AMENDMENTS TO THE DRAWINGS

Title: TAMPER RESISTANT PIN CONNECTION

Serial No. 10/014,384 - Filed November 9, 2001

FIGURE 3

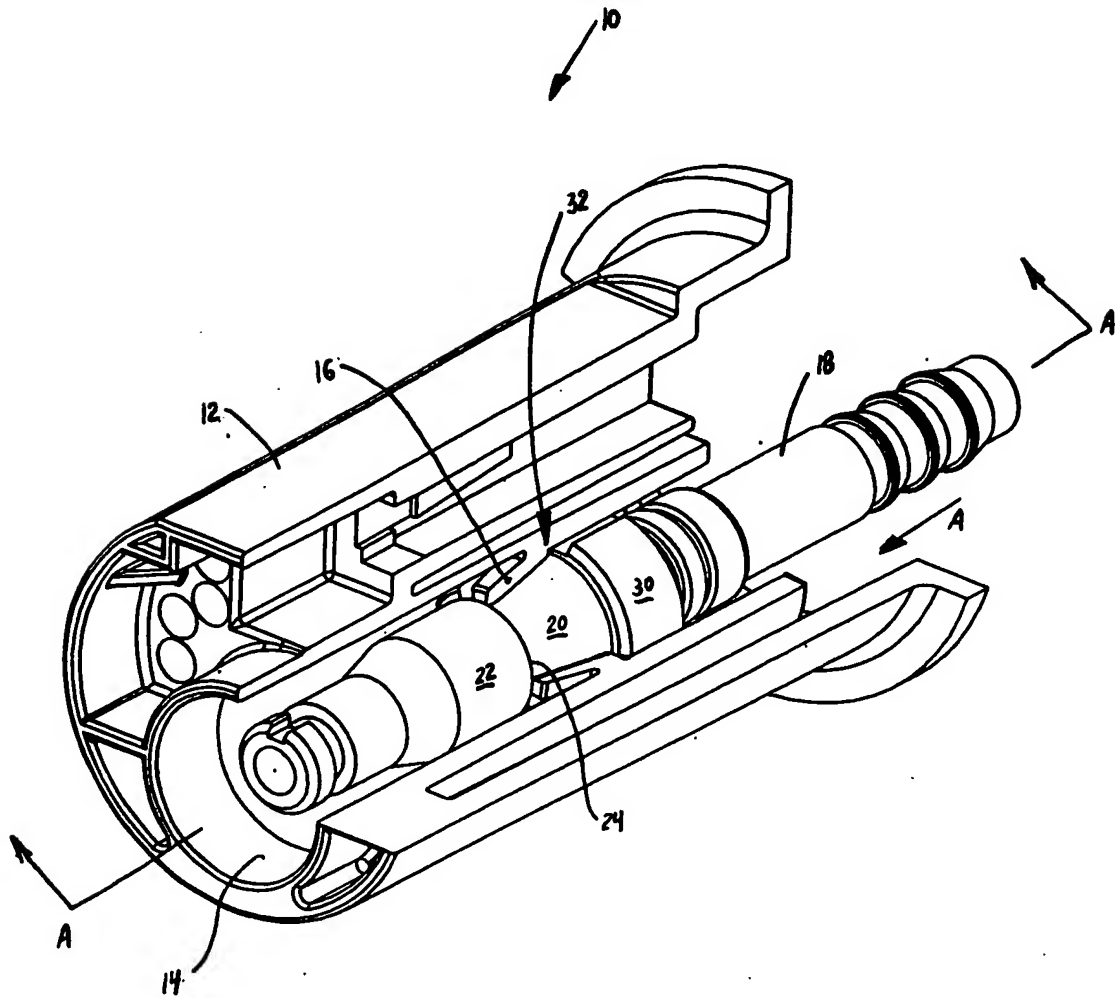
The drawings were objected to because it was unclear from Figure 3 where the housing ends and the pin begins particularly around feature 2. Applicants have amended Figure 3 to clarify where the housing ends and the pin begins around feature 2. Accordingly, Applicant submits herewith a replacement drawing sheet for Figure 3.
